Industry/TSTF Standard Technical Specification Change Traveler

Add example of SFDP to the 3.0.6 Bases

TSTF-71,
Rev. 2

EXAMPLES

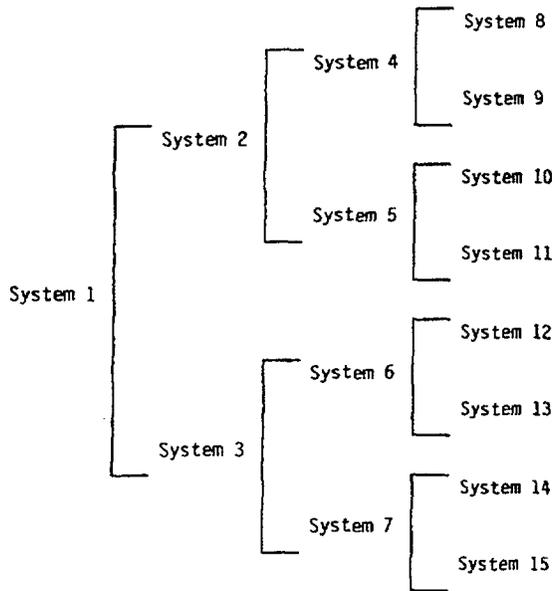
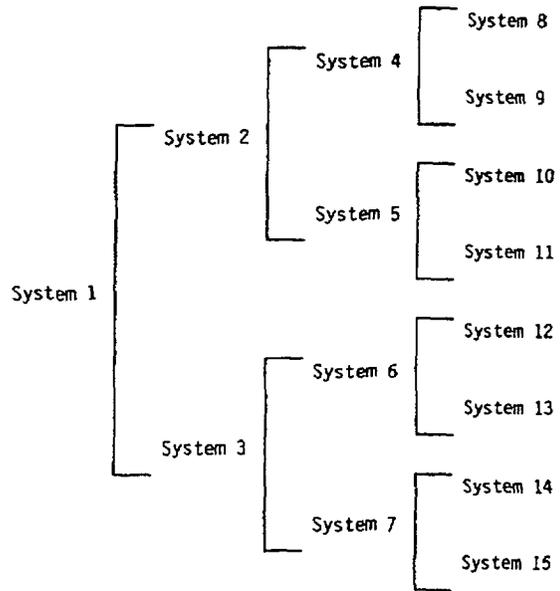
- a. A required system redundant to system(s) supported by the inoperable support system is also inoperable; or (EXAMPLE B3.0.6-1)
- b. A required system redundant to system(s) in turn supported by the inoperable supported system is also inoperable; or (EXAMPLE B3.0.6-2)
- c. A required system redundant to support system(s) for the supported systems (a) and (b) above is also inoperable. (EXAMPLE B3.0.6-3)

If System 2 of Train A is inoperable, and System 5 of Train B is inoperable, a loss of safety function exists in supported System 5.

If System 2 of Train A is inoperable, and System 11 of Train B is inoperable, a loss of safety function exists in System 11 which is in turn supported by System 5.

If System 2 of Train A is inoperable, and System 1 of Train B is inoperable, a loss of safety function exists in Systems 2, 4, 5, 8, 9, 10 and 11.
